CERTIFICATE OF APPROPRIATENESS

Property: 1202 Ashland Street, Lot 19, Tract 20A, Block 182, Houston Heights Subdivision. The property includes a historic 3,018 square foot, two-story wood frame single-family residence and detached garage situated on a 6,600 square foot (50' x 132') corner lot.

Proposal: Alteration – Addition

Recommendation: Denial - does not satisfy criteria 8&9
HAHC Action: -

Side Wall Length and Insets (Addition and New Construction)

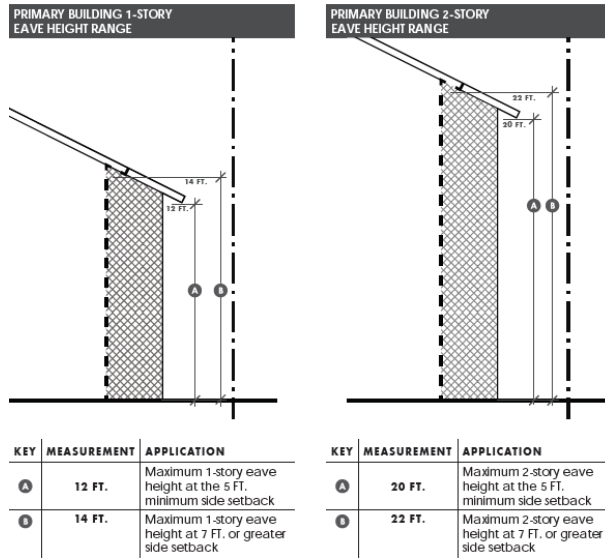
Max side wall length: 42'-7"
Side Wall inset depth: no inset at the rear original corner

LOCATION OF ORIGINAL FRONT CORNER 2 (FC2)

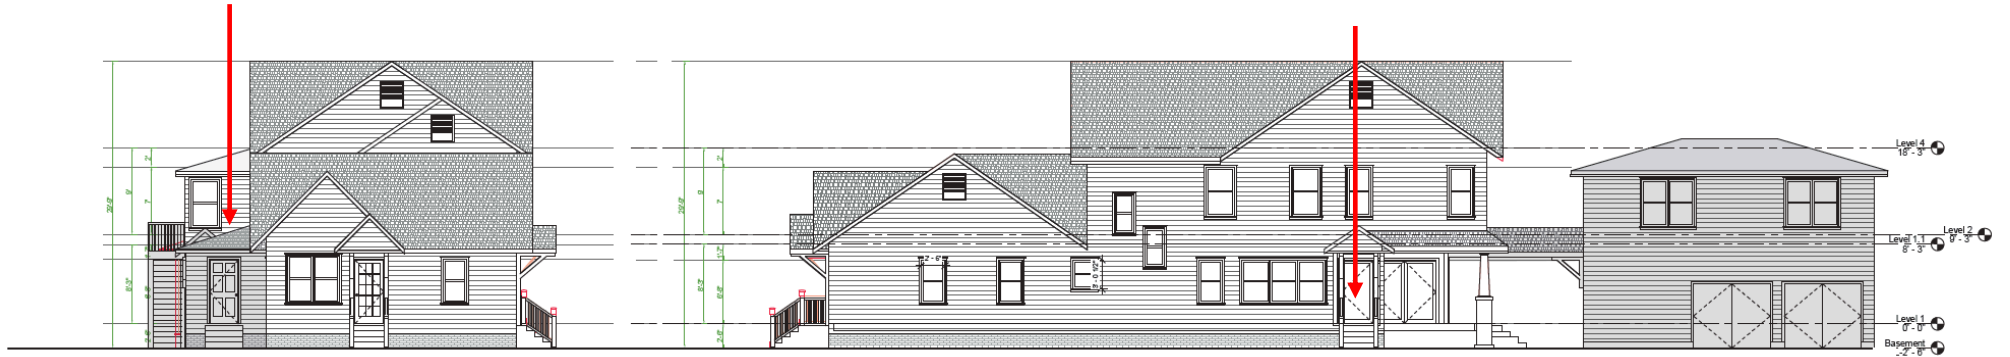
- Based on the available information, it is evident that at least 2 of the 4 original corners have not been retained over the building's history (refer areas highlighted in red).
- Front corner 2 (FC2) originally had a porch which was absorbed into the house to create an en-suite bathroom (date unknown).
- Rear corner 1 (RC1) has been integrated into the design of a 2-story addition and screened porch, circa 2013.
- FC2 and RC1, the altered corners, are both highly visible from the street, arguably already significantly impacting the Historic integrity of the building.
- Rear corner 2 (RC2) in proposed design is not visible from any vantage point.

PROPOSED WEST ELEVATION
ASHLAND STREET FRONTAGE

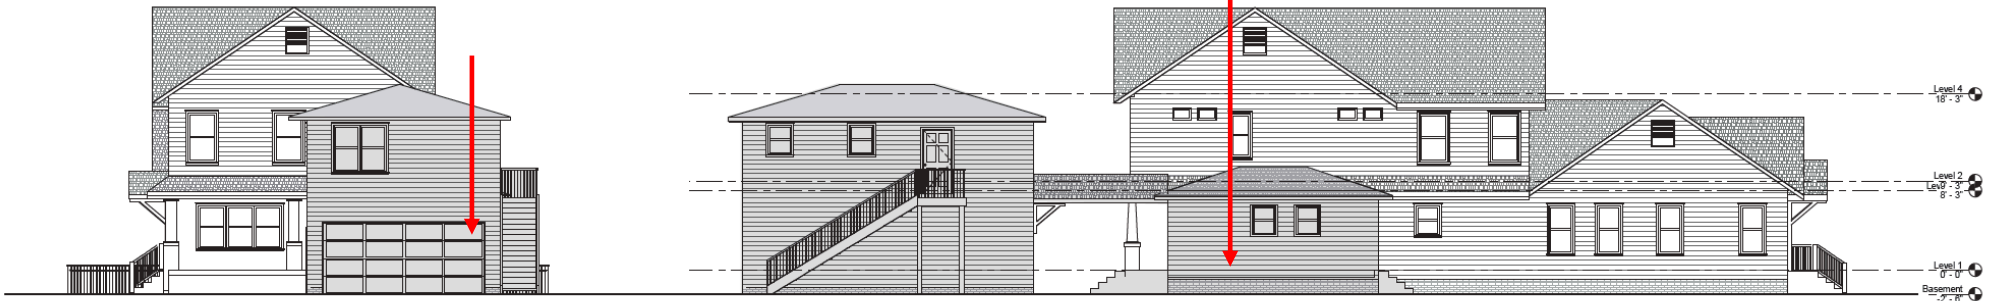
- Rear Corner 2 is currently not, and will not be, visible from East, West, or South Elevations (see above **RED** indicator arrow).
- Rear Corner 2 is currently not, and will not be, visible from the rear alley, Ashland Street or 12th Street.
- Currently only seen when onsite on the North elevation which runs alongside site boundary to neighboring properties.
- NB*Neighboring buildings are non-contributing structures.

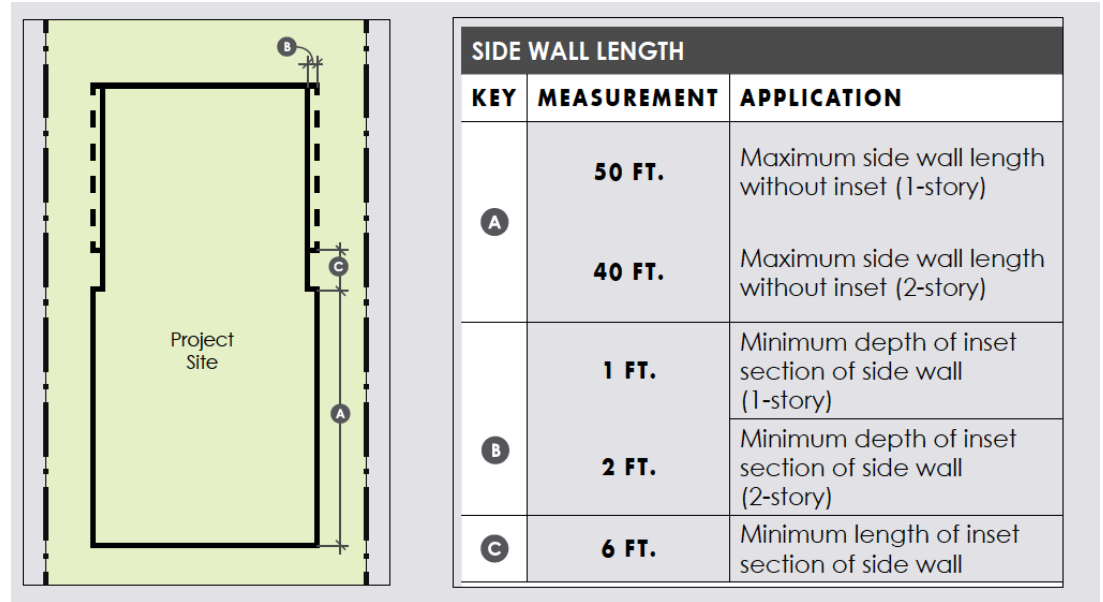
Siding in the area of proposed addition is not original.

Evidence of removal of prior windows (or doors).

- Prior renovation completed in 2013 does not meet the 2FT minimum inset requirements for a 2-story addition.
- Note, siding has also been replaced in this section of the Rear Corner 2.

1202 ASHLAND STREET FOR REVIEW

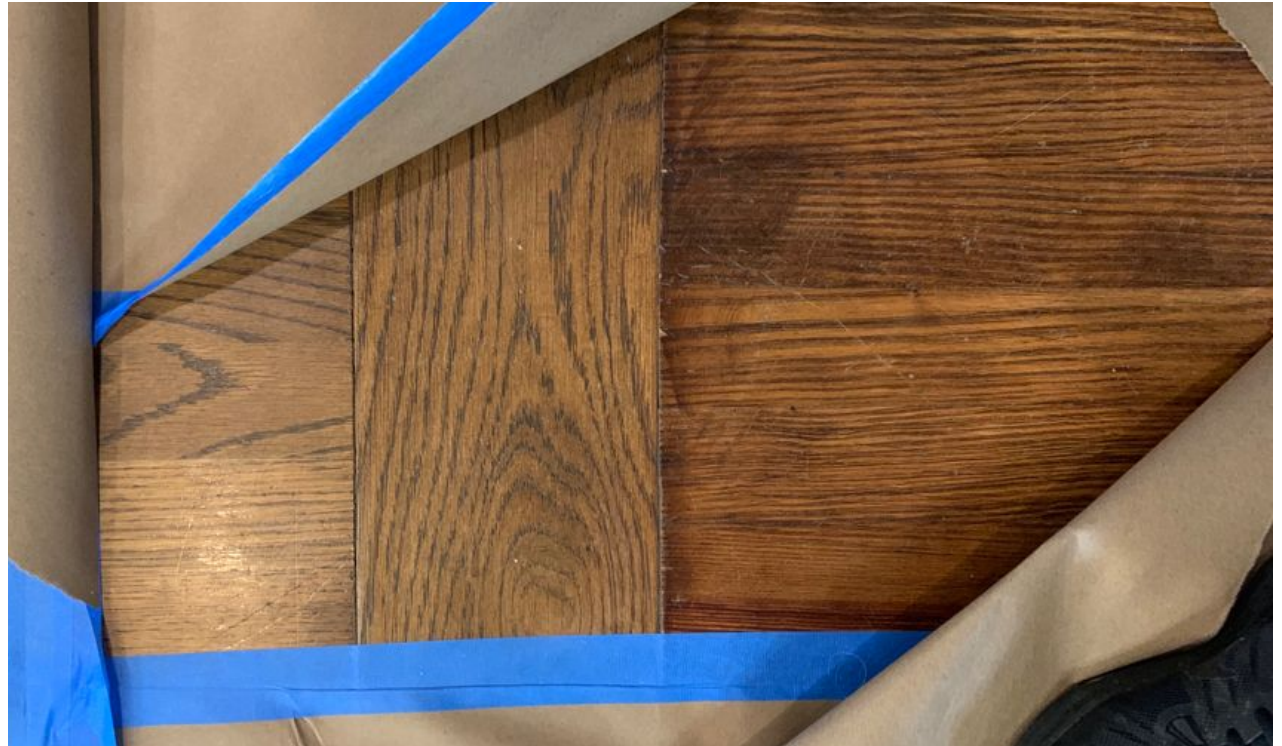
- Some onsite evidence to suggest area highlighted may have been either a porch or screened porch at some point in the building's history.
- Notice flooring change between kitchen and area highlighted (Refer photo below).
- Existing plan from 2012, shows this area to be open plan – unusual for bungalows of this era to have such a design.
- Suggests, none of the rear original corners have been retained over the building's history.
